ADDENDUM

ADDENDUM NO.: 02
PROJECT NAME: Kenwood Academy Link and Mechanical (Rebid)
PROJECT NO.: 05326
CONTRACT NO.: C1602R
DATE OF ISSUE: February 29, 2024

NOTICE OF CHANGES, MODIFICATIONS, OR CLARIFICATIONS TO CONTRACT DOCUMENTS

Project Name: Kenwood Academy Link + Mechanical
 PBC Contract No: C1802R
 Project No: 05208
 Title: MECHANICAL PENTHOUSE PLANS - KENWOOD (BUILDING C)
 Sheet: M103-MEP

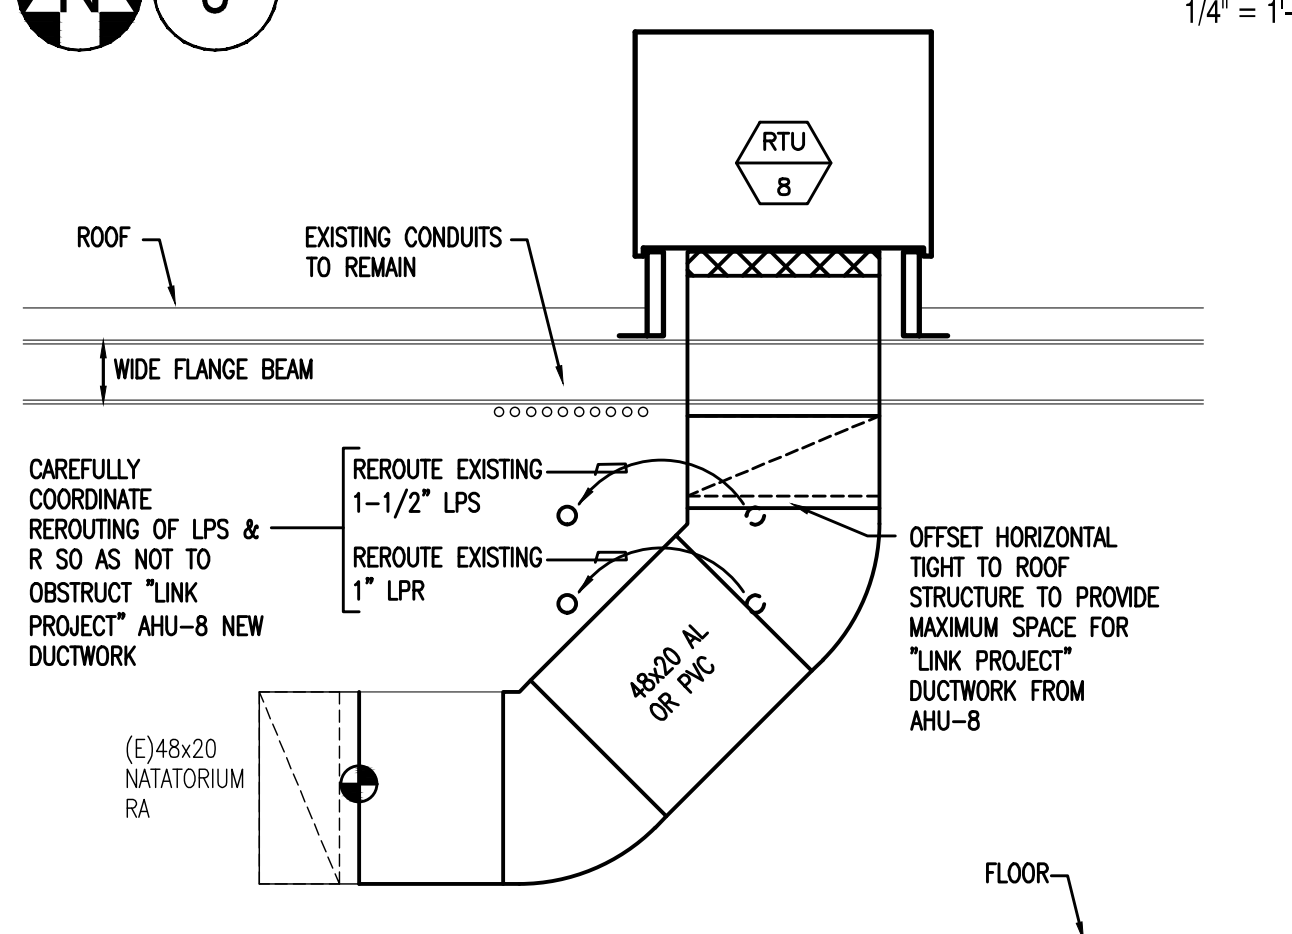
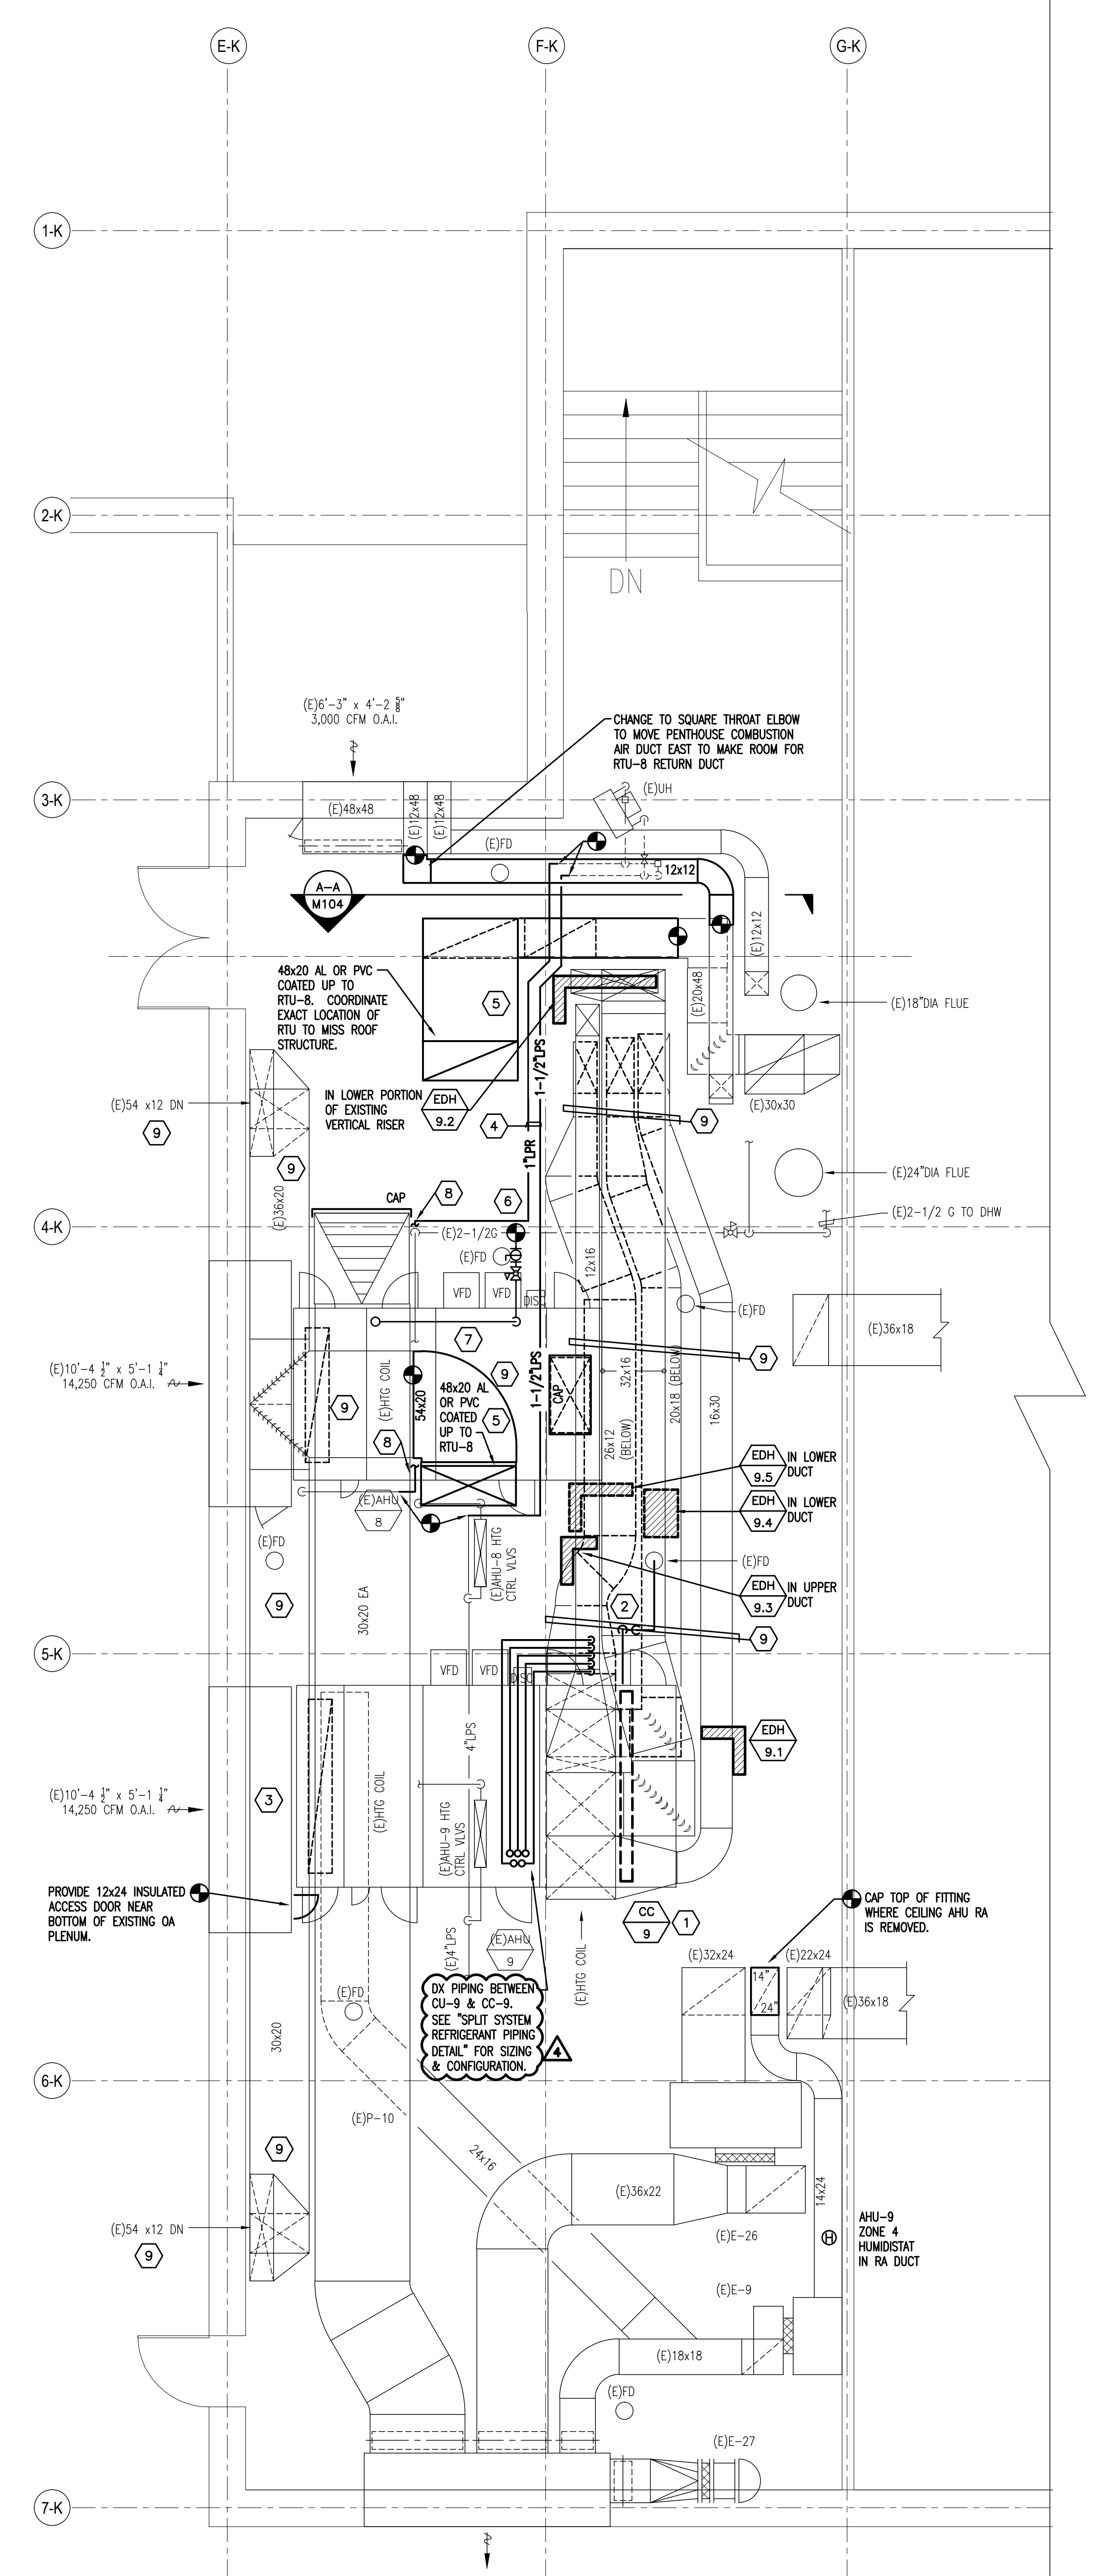
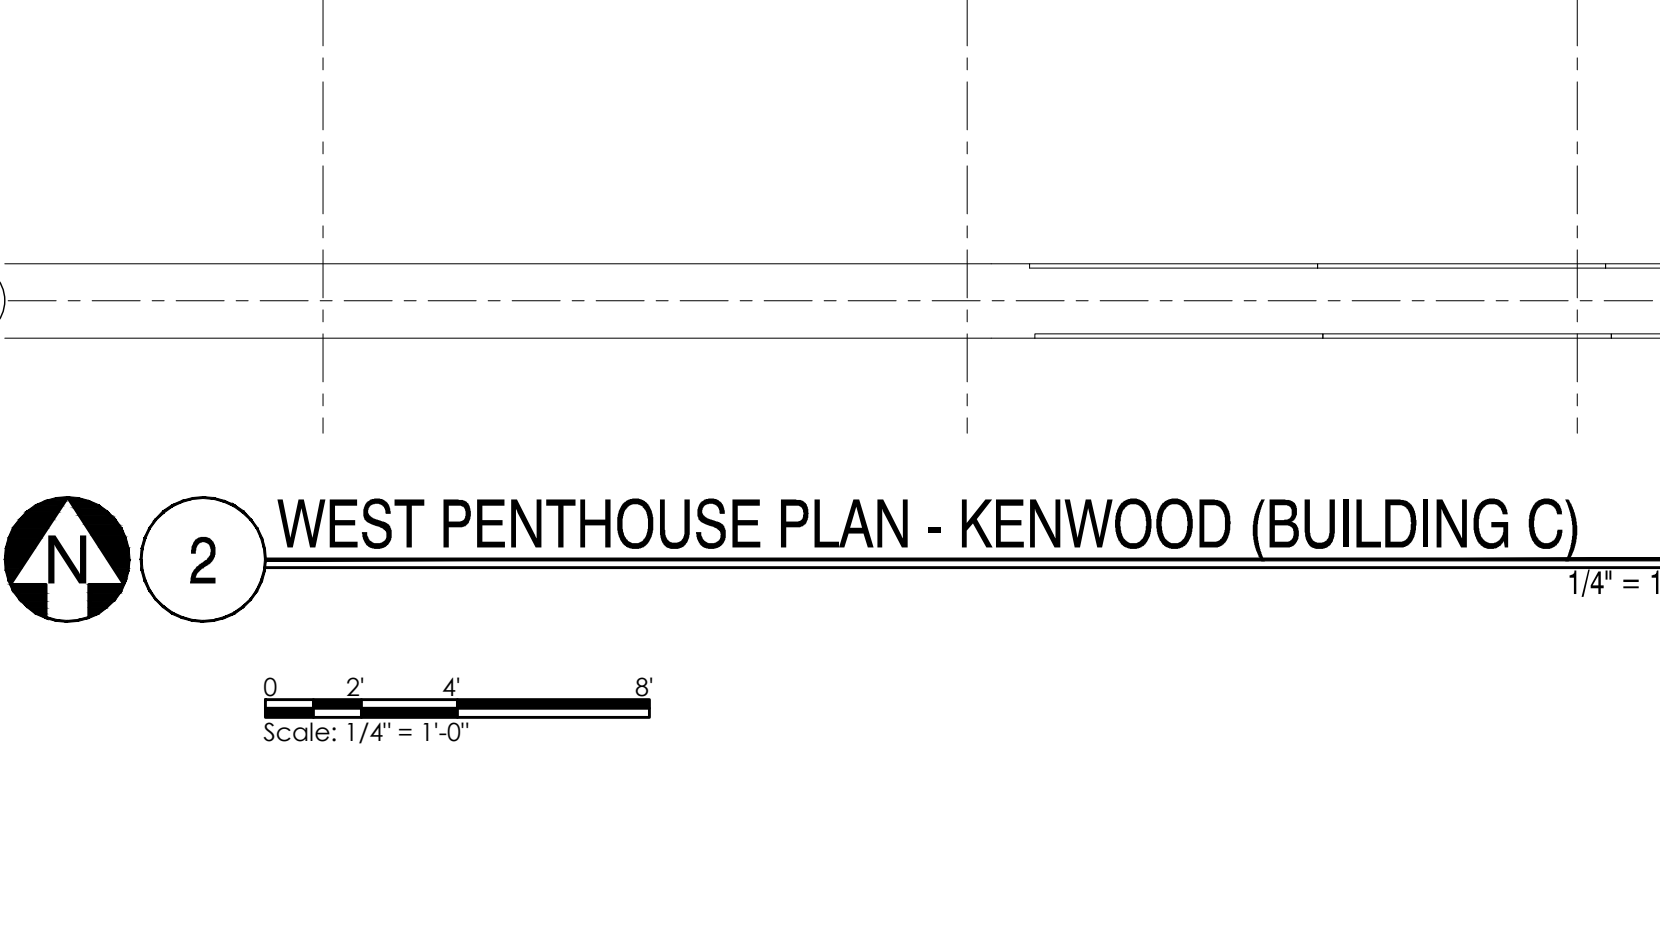
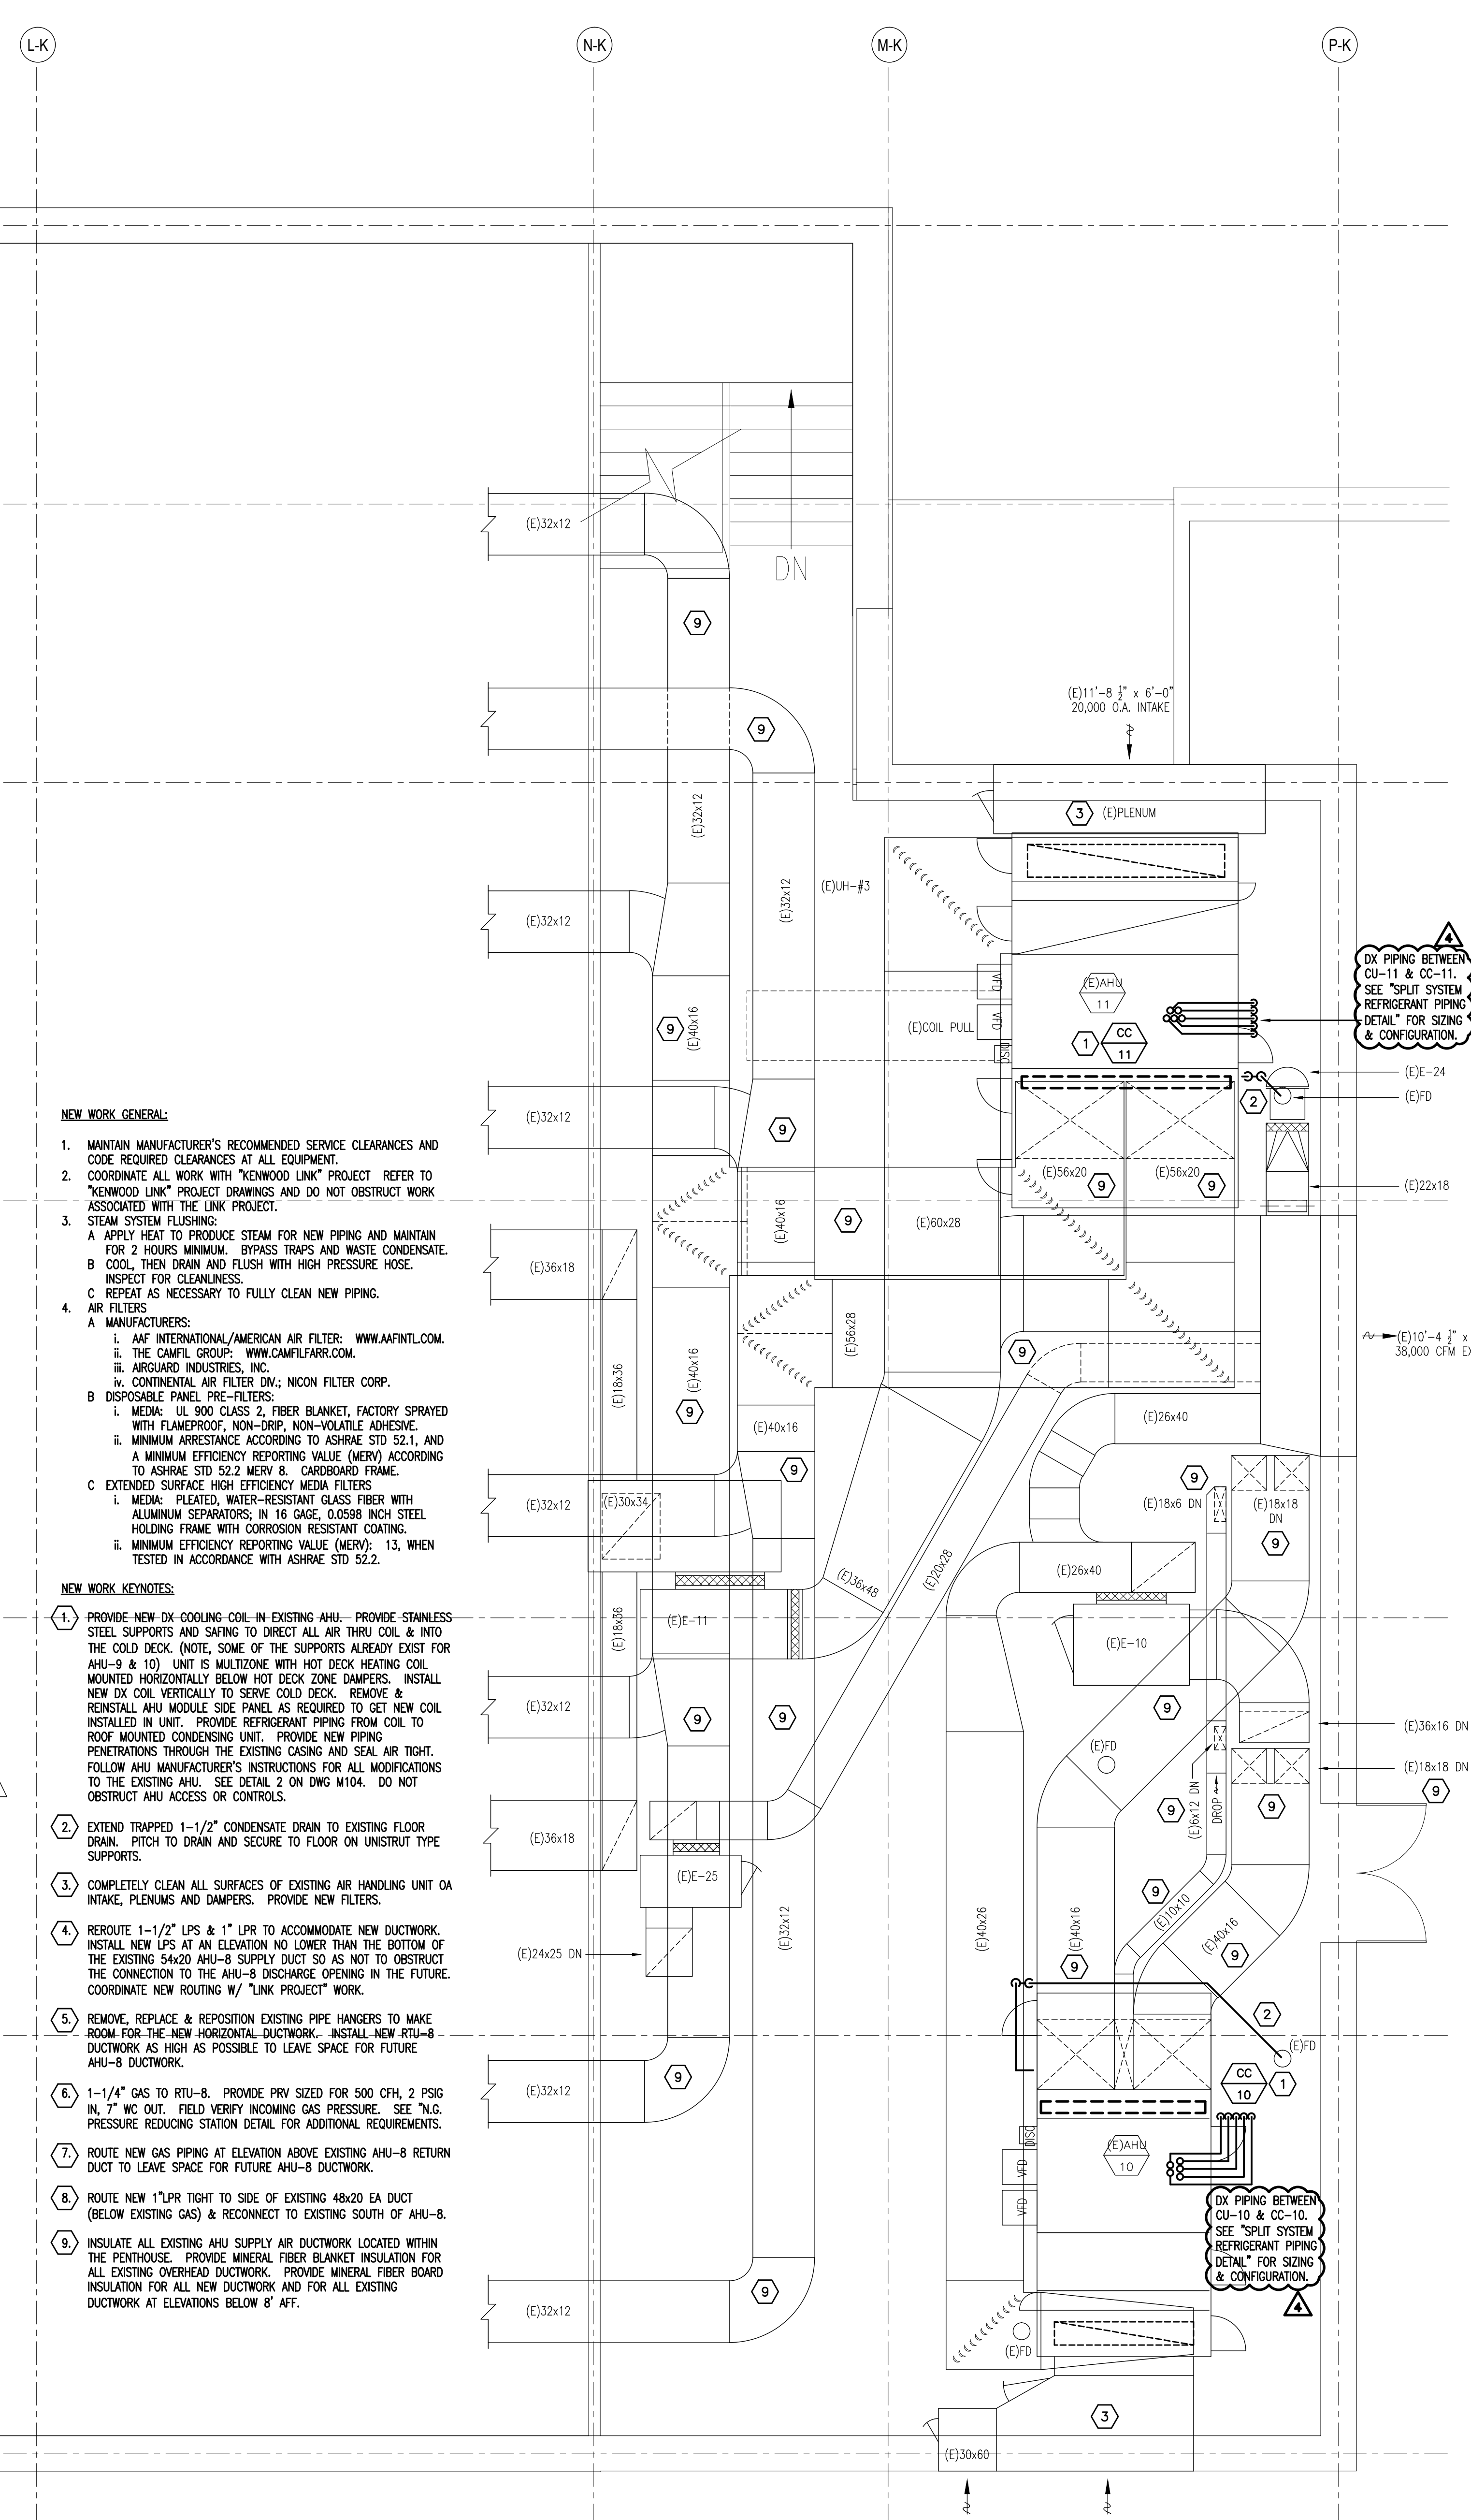
- Change 14** **REVISED** Drawing M103-MEP MECHANICAL PENTHOUSE PLANS: KENWOOD (BUILDING C) Updated DX pipe sizing
- Change 15** **REVISED** Drawing M104-MEP MECHANICAL ROOF PLANS - KENWOOD (BUILDING C): Updated DX pipe sizing & condensing unit weights
